FINAL
Environmental Impact Report
Merced Gateway Master Plan
City of Merced, Merced County, California
State Clearinghouse Number 2015101048

Date: June 7, 2017

SECTION 2: RESPONSES TO WRITTEN COMMENTS

Exhibit 1

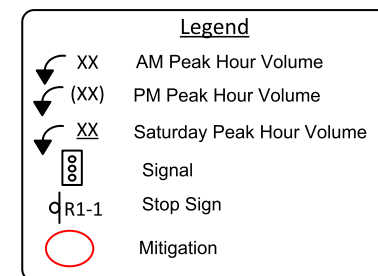
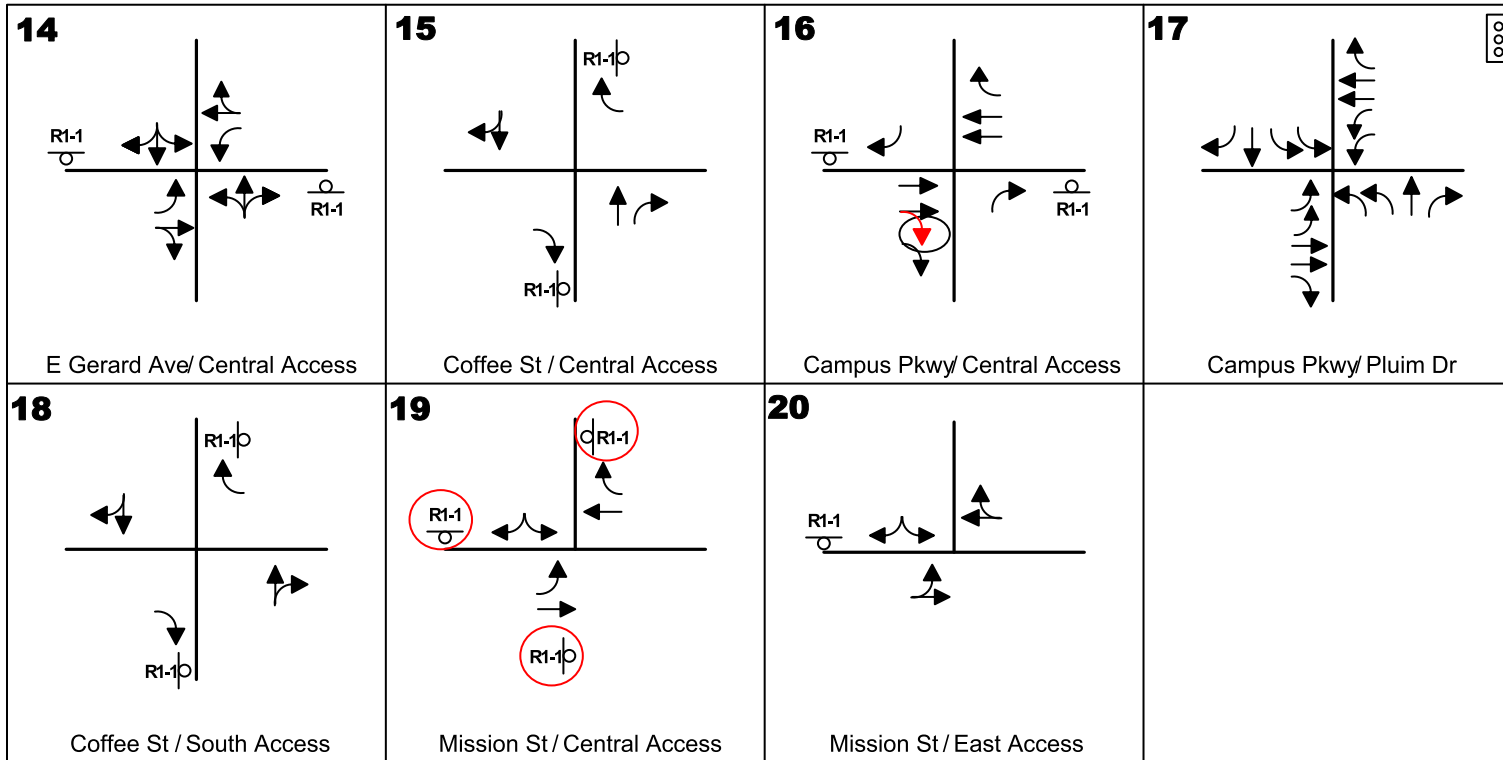
The project applicant requests that the project description be amended to Match Alternative 2 of the Circulation Element Alternative. After further discussion between the project applicant and the adjacent property owner, it was determined that the Pluim Drive extension would provide greater access for both property owners and advance and enhance all of the project objectives. We intend to commence construction of the Pluim Drive Extension no later than the issuance of the first building permit for phase 5 of the project. One half of the roadway will be located on the Merced Gateway, LLC property (adjacent land owner) and the other half on Gateway Park Development Partners, LLC property. Attached hereto is a revised site plan that includes the construction of the Pluim Drive extension. Please advise at your earliest convenience if additional information is needed to amend the project description.

Exhibit 3.11-11 Mitigations Existing Plus Project / Access as Proposed Lane Configurations

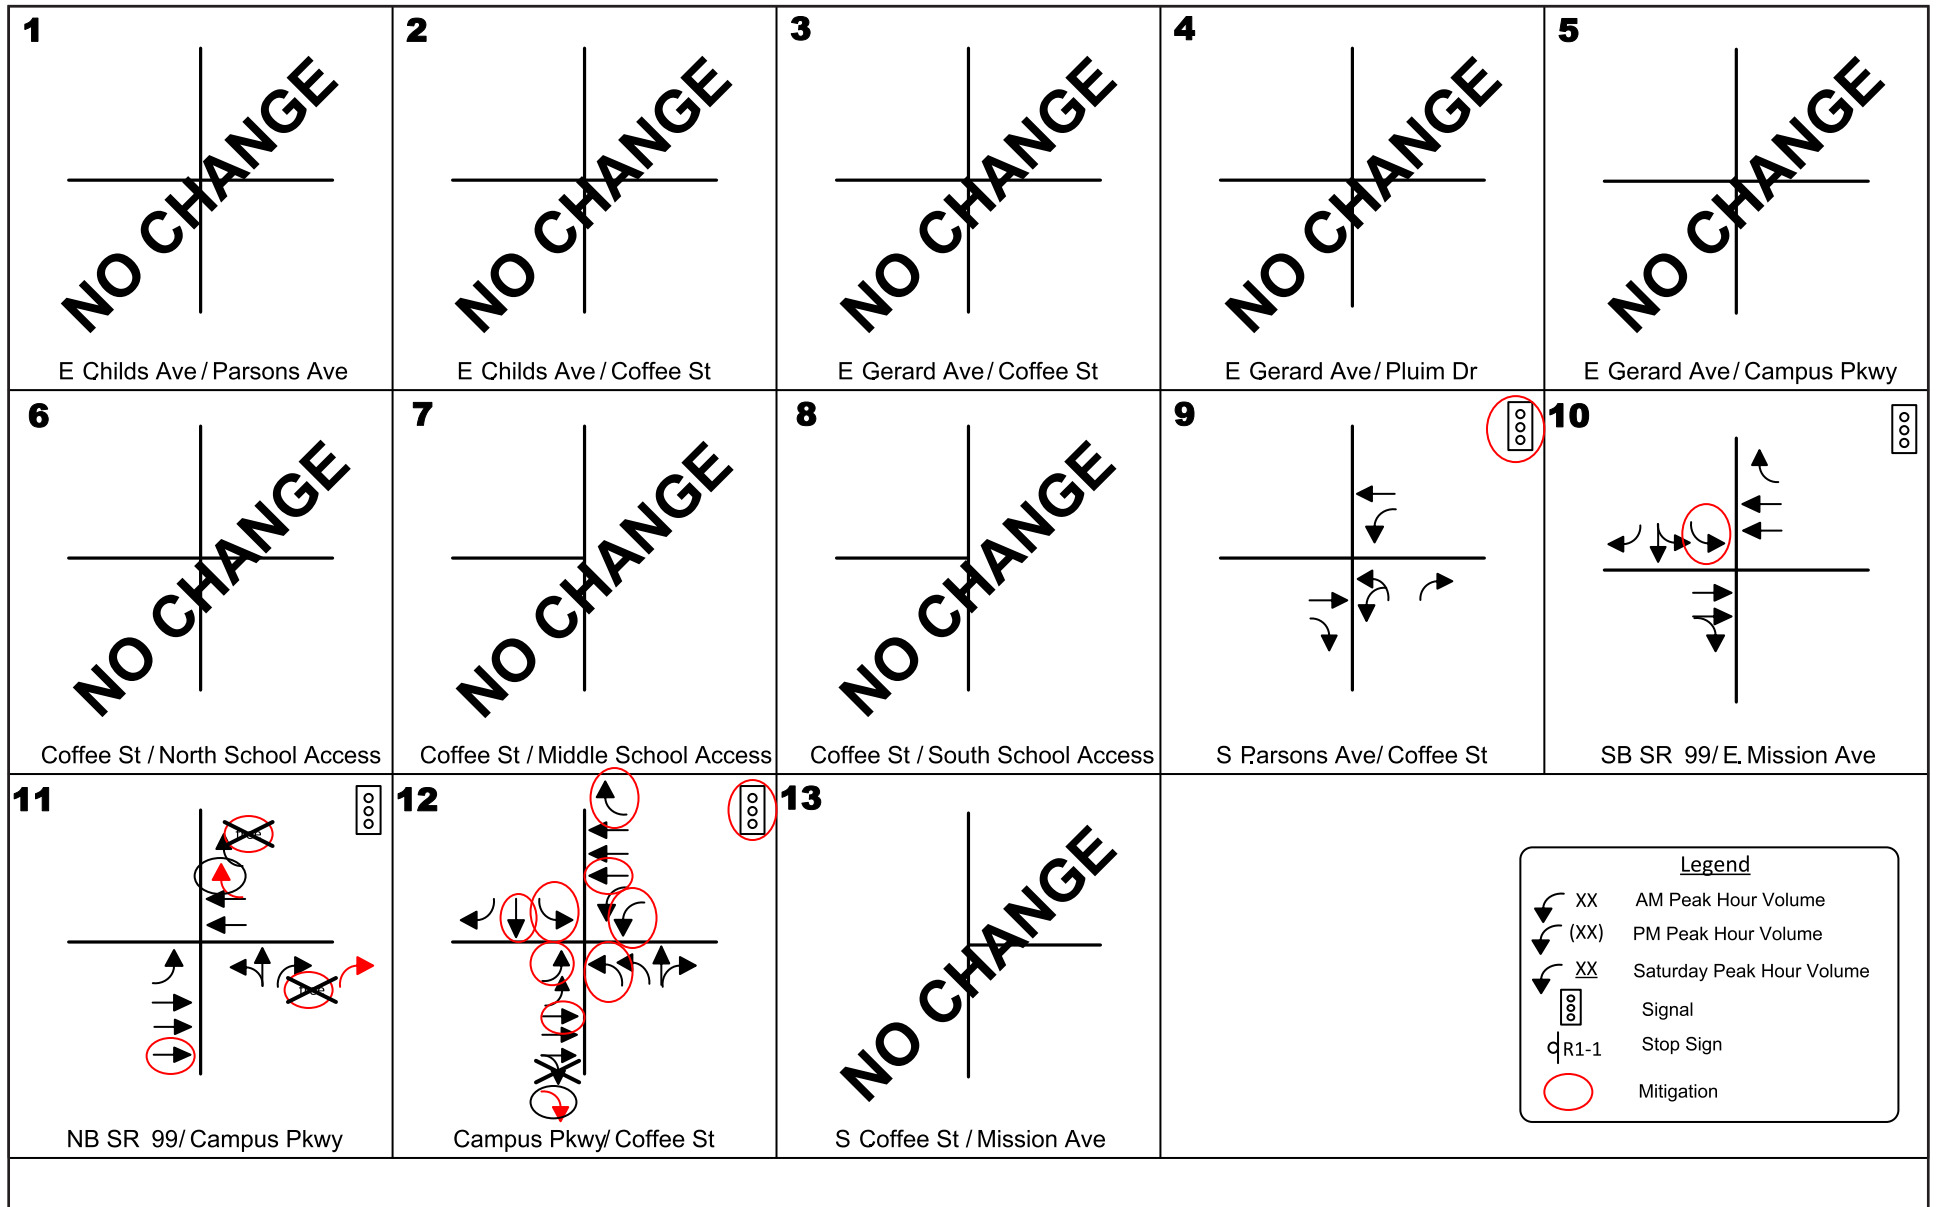
<p>d. According to Figure 22 (Mitigations for Existing Plus Project/Access as Proposed) and Figure 24 (Mitigations for Existing Plus Project with General Plan Streets) of the TIS, there will be two WB left-turn lane at Campus</p>	<p>13</p>

The commenter points out that according to Figure 22 (Mitigations for Existing Plus Project/Access as Proposed) and Figure 24 (Mitigations for Existing Plus Project with General Plan Streets) in the Traffic Study would require a second westbound left-turn lane at Campus Parkway/Coffee Street, but review of that second left-turn lane is not provided in the Mitigation Synchro file.

The City of Merced and Caltrans have consulted on the issues associated with the State Route 99 (SR-99)/Mission Avenue intersection and have identified an applicable strategy to address these concerns noted in this comment. The northbound SR-99 ramps approach to Mission Avenue will not include a "free" right-turn lane, but instead a second northbound right-turn lane will be provided. These improvements would be required for both the proposed project and the GP Circulation Alternative. In addition, a second right-turn lane will be provided at the project's mid-block driveway on Campus Parkway under the proposed project and the eastbound shared through/right

turn at Coffee and Campus Parkway will be split into a separate through lane and separate right-turn lane. These changes are noted in the revised Figures 22, 23, 24, 26, 27, 28, and 29 and revised Tables 37, 41, and 43 from the Traffic Study in Appendix I to the DEIR and the corresponding Exhibits 3.11-11, 3.11-12, 3.11-13, 3.11-18, 3.11-19, 3.11-24, 3.11-25, and 3.11-26 and Tables 3.11-16, 3.11-28, 3.11-37, 3.11-38, and 3.11-39, which are included in the Errata to the Draft EIR as part of this Final EIR.

Exhibits 3.11-11, 3.11-12, 3.11-13, 3.11-18, 3.11-19, 3.11-24, 3.11-25, 3.11-26, and 3.11-27, and Tables 3.11-16, 3.11-28, 3.11-37, 3.11-38, and 3.11-39 from the DEIR (corresponding to Figures 22, 23, 24, 26, 27, 28, and 29 and revised Tables 37, 41, and 43 from the Traffic Study in Appendix I of the DEIR) are also changed to reflect the revised mitigation measures and the correction to the Mitigated Cumulative Year 2035 condition for Mission Avenue/State Route 99 northbound and southbound ramps, from LOS “D” to “B” in the AM Peak Hour, and the Mission Avenue/State Route 99 southbound ramps from LOS “C” to “B” in the PM peak hour. The revised pages of the EIR follow.

Exhibit 3.11-24 Mitigations Cumulative Plus Project / Access as Proposed Lane Configurations

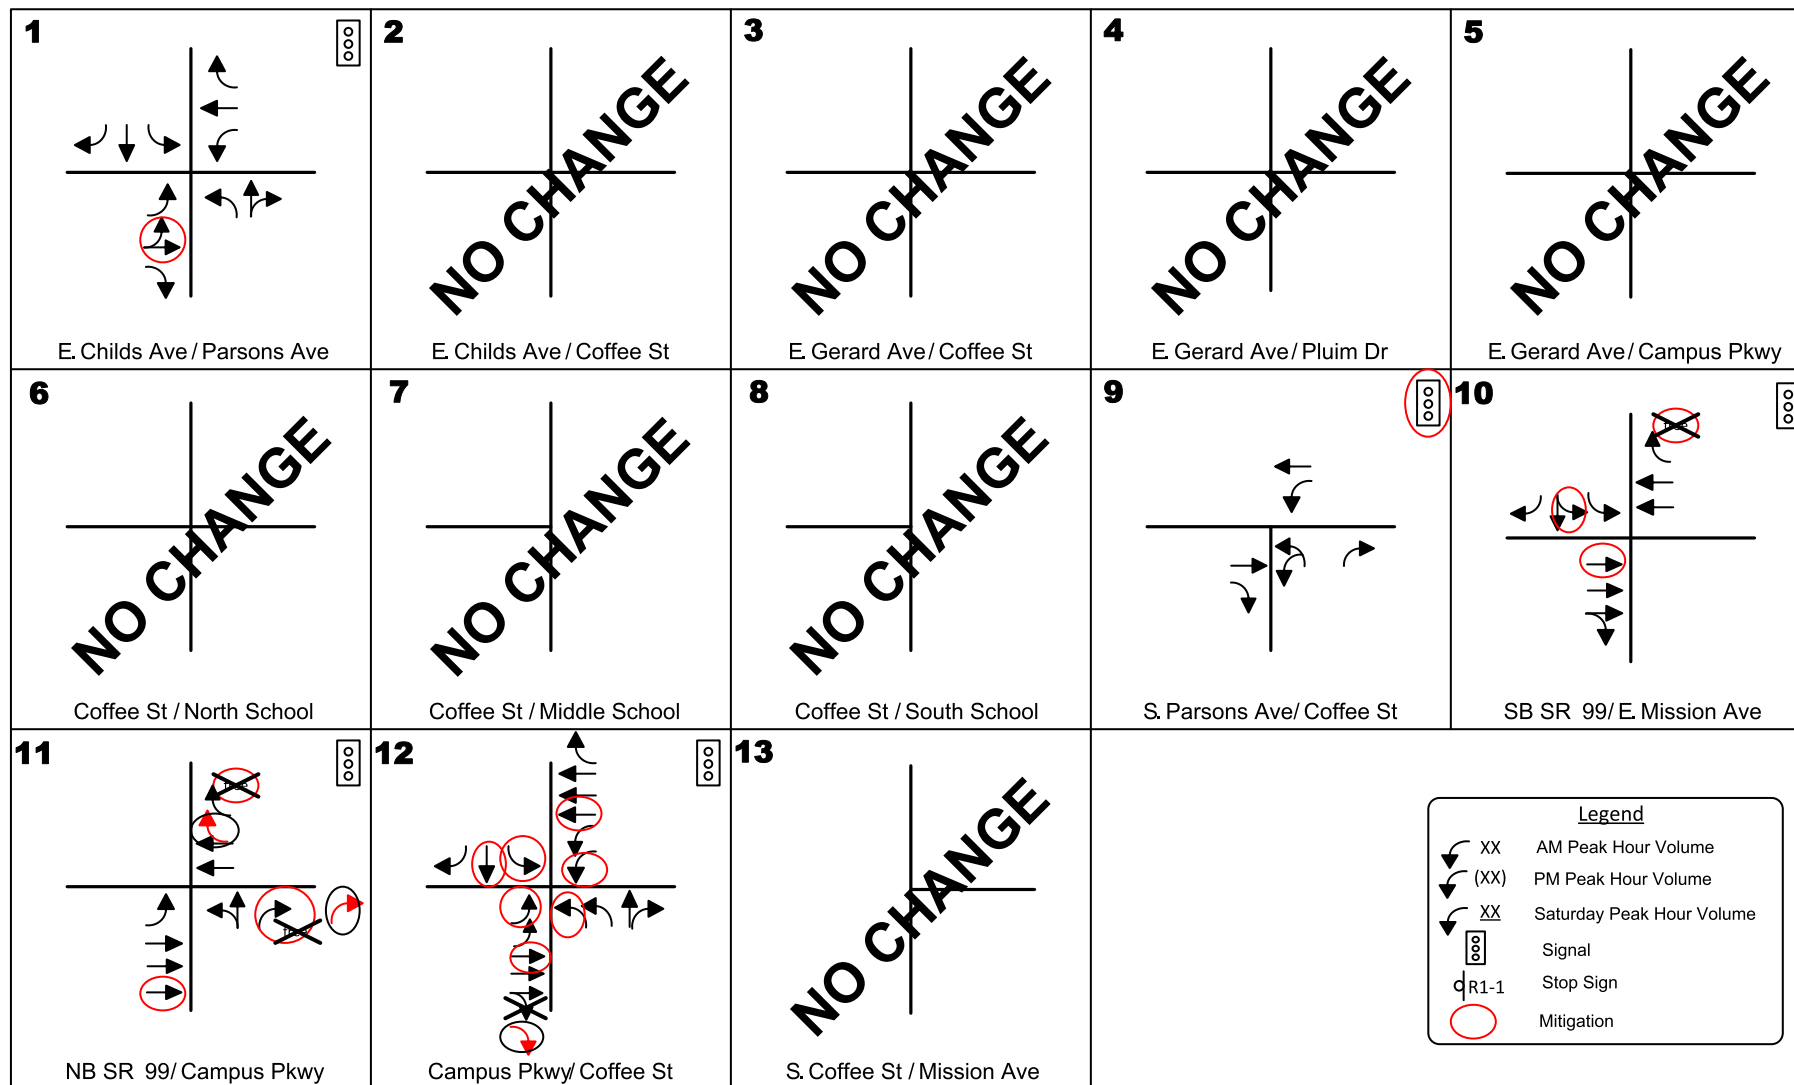
7. The DEIR's TIS needs to be revised to provide feasible mitigations under "EPAP Plus Project and Cumulative Plus Project Access as Proposed". The TIS analyzes the traffic impact under this condition, and indicates that the adjacent approved projects will worsen the traffic conditions at the ramp intersections and adjacent intersections, in addition to impacts from the Merced Gateway project. The TIS proposes the using the same "Existing Plus Project" mitigations as the mitigation for the "EPAP Plus Project & Cumulative Plus Project Access as Proposed". However, these proposed mitigations do not mitigate the project's significant impacts to traffic. For example, with these mitigations at the SR-99 NB Ramps/Mission Ave, the LOS is still E and F in the PM peak and Saturday as shown in Table 42, Mitigated EPAP Plus Project Conditions, Merced Gateway TIS.

The City of Merced and Caltrans have consulted on the issues associated with the SR-99/Mission Avenue intersection and have agreed that the mitigation measures as revised above are sufficient to address these concerns. The resulting Levels of Service (LOS) would be similar to those identified in the DEIR but would still result in significant and unavoidable impacts as indicated in the DEIR.
